Technical News 161
January 2015
Strictly Confidential

Contents		
Item	Subject	Model Affected
Item 1.	Clutch Cable	Thunderbird - All Models Except Thunderbird Commander and Thunderbird LT
Item 2.	Pannier Strap Parts kit	Sprint GT, Tiger 800 (All Models), Tiger Sport, Tiger Explorer, Tiger Explorer XC, Trophy and Trophy SE

- 1. Clutch cable free length
- 2. Clutch actuation lever

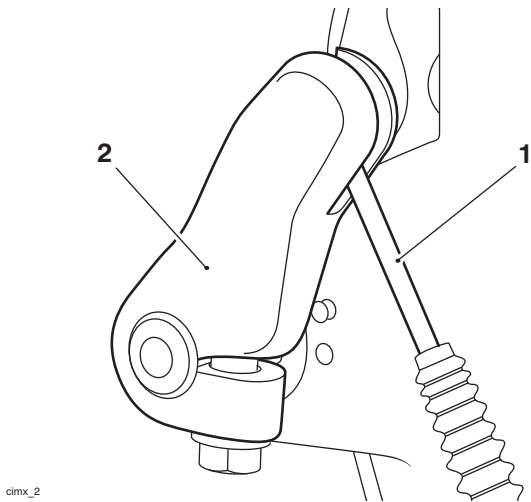
A new clutch cable has been introduced to the above models from VIN 693388 and is retrofittable. Parts no longer support the original clutch cable.

The difference between the original and new condition clutch cable is that the inner cable's free length at the clutch actuation lever is 18 mm longer than the original. The additional length is to allow the repositioning of the clutch actuation lever to eliminate any possibility of clutch drag.

The fitting of the new condition clutch cable is the same as for Thunderbird Commander as described in the Service Manual and Technical News 158 issued 07/2014.

1. Pannier lid retaining strap (male shown, female similar)
2. Rivet

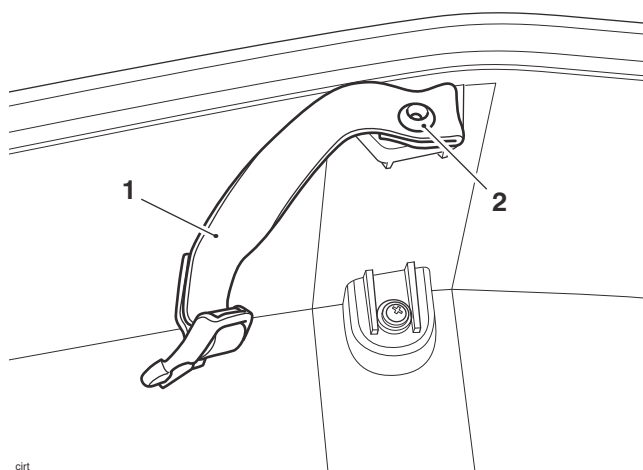
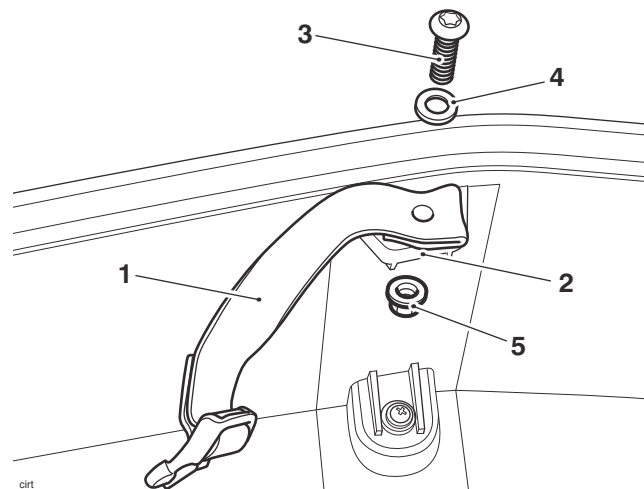
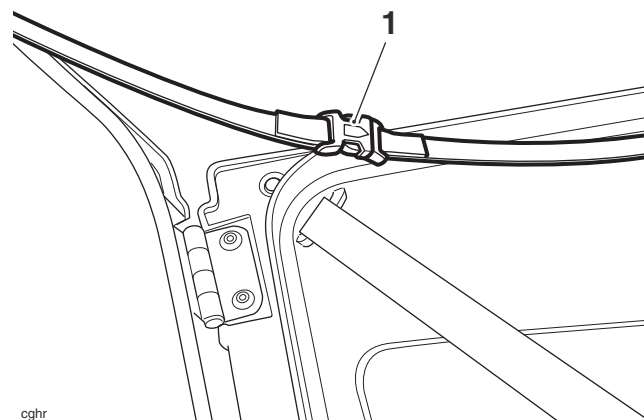
New pannier lid retaining straps have been introduced to the panniers on the above models.

- The new pannier lid retaining straps feature buckles that are not compatible with the old condition straps.
- Parts will no longer support old condition pannier lid retaining straps.

Parts kit T2357006 has been released for use when replacing old condition pannier lid retaining straps.

3. To remove the old pannier lid retaining straps, using a suitable drill, drill through the head of the rivets securing the pannier lid retaining straps to their mounting points. Remove and discard the straps, rivets and washers.

5. Align the new pannier lid retaining straps to their mounting points as noted during removal and secure with the fixings as shown.

6. Ensuring that the straps remain correctly aligned, tighten the fixings to **1.5 Nm**.
7. Partially close the lid and join the lid retaining strap buckles together, then fully close the lid.

1. Three-pin multiplug (up to engine number 596480)

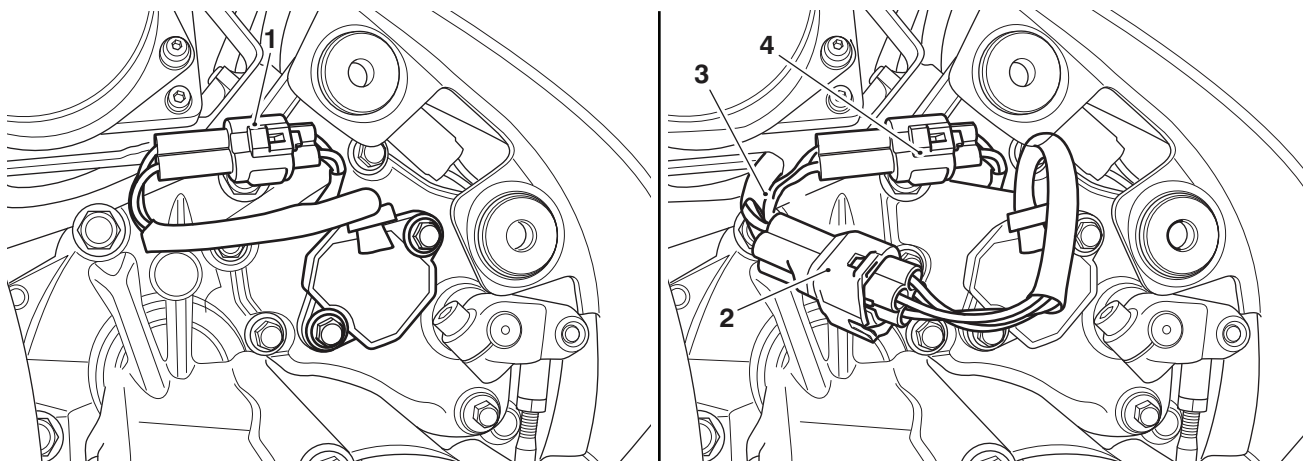
A new main wiring harness has been introduced to the above model from engine number 693353. The new main harness has the four-pin multiplug for the gear position sensor and can be connected to it without the use of a fly lead.

Prior to ordering the parts kit, check to see if the gear position sensor has the four-pin multiplug. If it has the four-pin multiplug only the new main wiring harness (part number 2500857) is required.

If the gear position sensor has the four-pin multiplug, only replace the main wiring harness.

If the gear position sensor has the three-pin multiplug, the gear position sensor must also be replaced using the parts kit T2500837.

After fitting the new main wiring harness and the gear position, cable tie the gear position multiplug to the ABS modulator bracket. Trim off any excess cable tie.

Circuit Diagrams

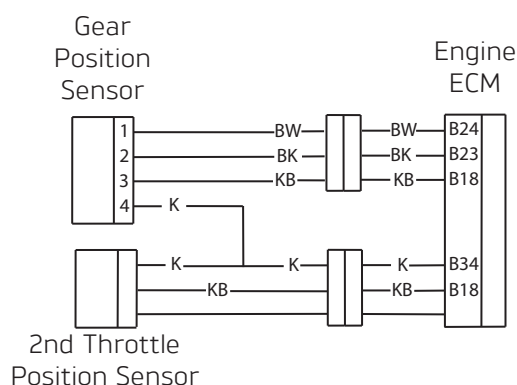
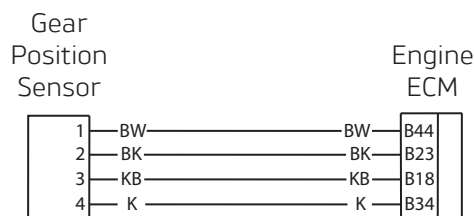
The gear position sensor pinpoint test procedure has also changed. The pinpoint test procedure for the new gear position sensor and old gear position sensors with a fly lead is as follows:

1. Side stand bracket
2. Fixing
3. Side stand

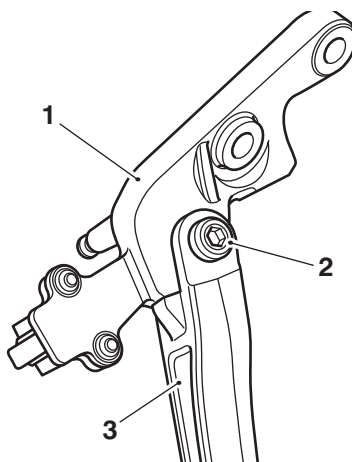
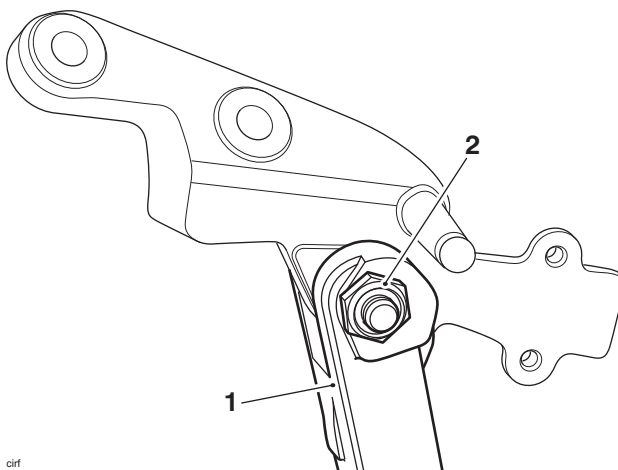
A revised bolt has been introduced on the above models from VIN 670401. If removed or replaced for any reason tighten the bolt and lock nut as described below.

1. Tighten the side stand bolt to **20 Nm**.

2. Whilst ensuring the bolt does not turn, tighten the lock nut to **9 Nm**.

1. Rear direction indicator fixings
2. Front direction indicator fixings

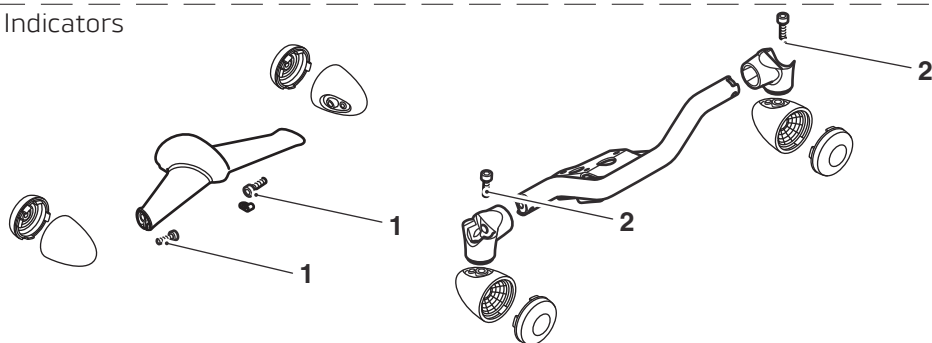
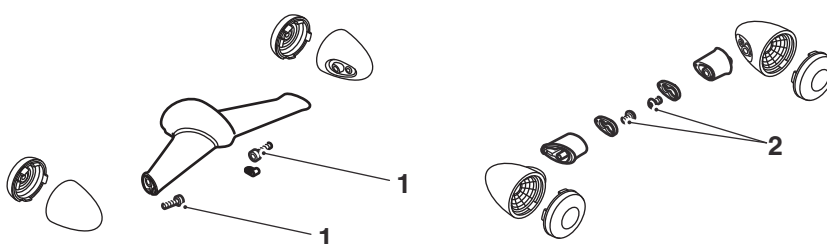
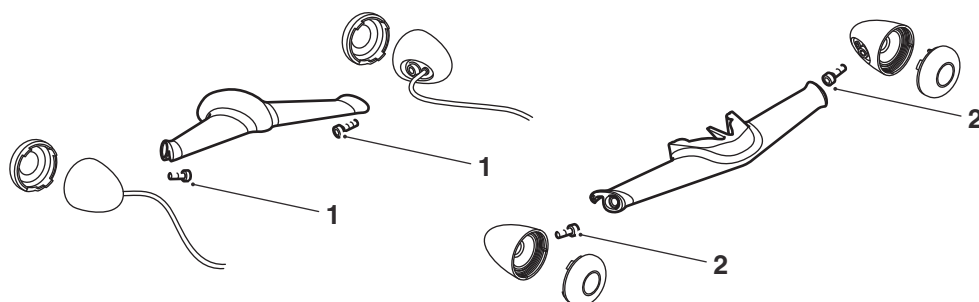
The fixings for the front and rear direction indicators have changed to encapsulated fixings on the above models.

The torque figure for these fixings has changed to **25 Nm**. These fixings must be replaced if they are loosened or removed.

1. Throttle position sensor fixings
2. Paint mark (yellow)

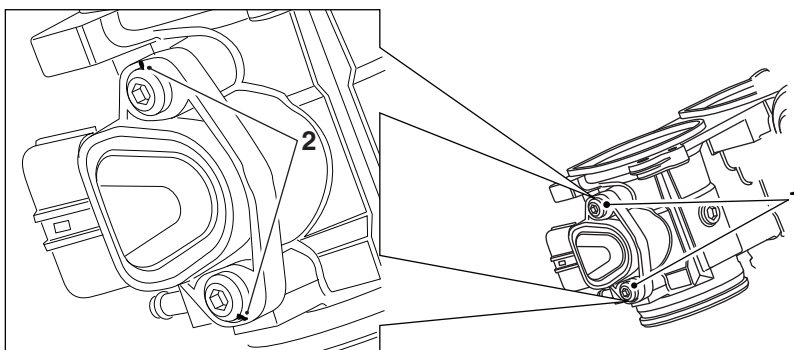
The throttle position sensor on the above models is an integral part of the throttle body and must not be adjusted or removed. Tampering with or removing the sensor will render the throttle body assembly inoperative and unusable, invalidating any warranty claims against the throttle body assembly.

The fixings for the throttle position sensor are marked with yellow paint and must not be loosened or removed.

If for any reason the throttle position sensor or the throttle bodies require replacement they must be replaced as an assembly.

If the fixings have been loosened or removed the throttle body assembly must be replaced as there are no means to reset the throttle position sensor to its correct position.

1. Fixing
2. Regulator rectifier bracket
3. Silencer hanger

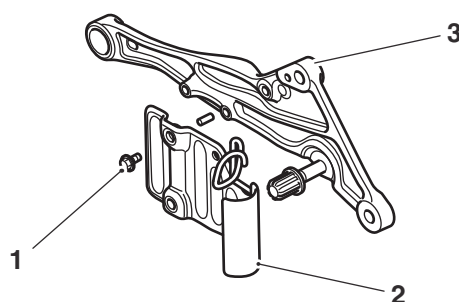
A revised fixing securing the regulator rectifier bracket to the rear footrest has been introduced on the above models. The revised fixing is pre-encapsulated and is retrofittable to earlier models.

1. Tighten the regulator rectifier bracket fixing to **7 Nm**.

1. Gear change return spring abutment fixing, Tiger Sport shown
Please mark your copy of the Service Manual with this information.

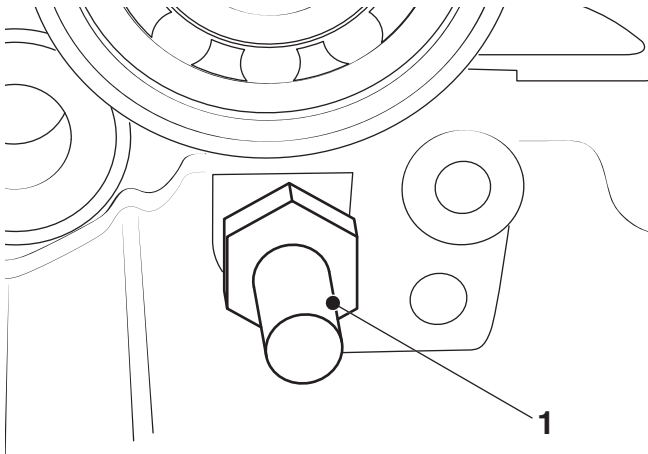
A revised abutment bolt has been introduced on the models listed in the table above. The revised abutment bolt is pre-encapsulated and is retrofittable to earlier models.

1. Tighten the abutment bolt to **15 Nm**.

1. Fixing
2. Coolant filler neck

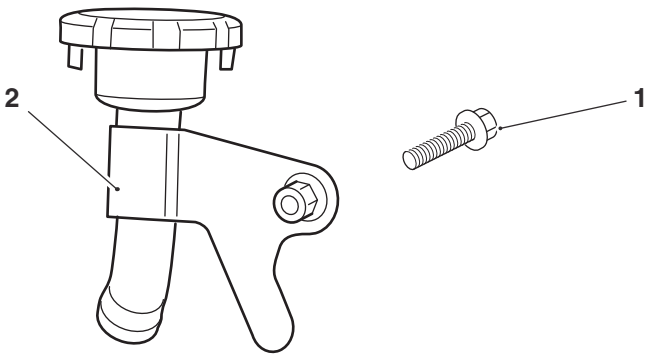
A revised fixing securing the coolant filler neck to the frame has been introduced on the above models. The revised fixing is pre-encapsulated and is retrofittable to earlier models.

1. Tighten the coolant filler neck fixing to **9 Nm**.
